## **PLAN REVIEW SHEET**

2016-065

Hotel Airport Partners, Inc.

Below is an image of the standard detail (60.01B) for the requested bus stop pad. Permanent easement is requested, where dimensions exceed existing or proposed right-of-way limits.

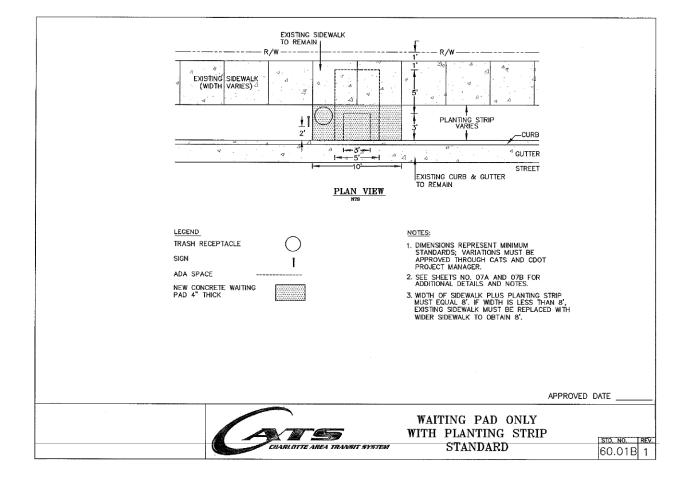
This site is located on an existing bus route. The Petitioner is requested to provide and construct a new waiting pad for a relocated bus stop on Wilkinson Boulevard. The proposed location of the bus stop is on the far western edge of the assembled development site (Parcel 1) along Wilkinson Boulevard.
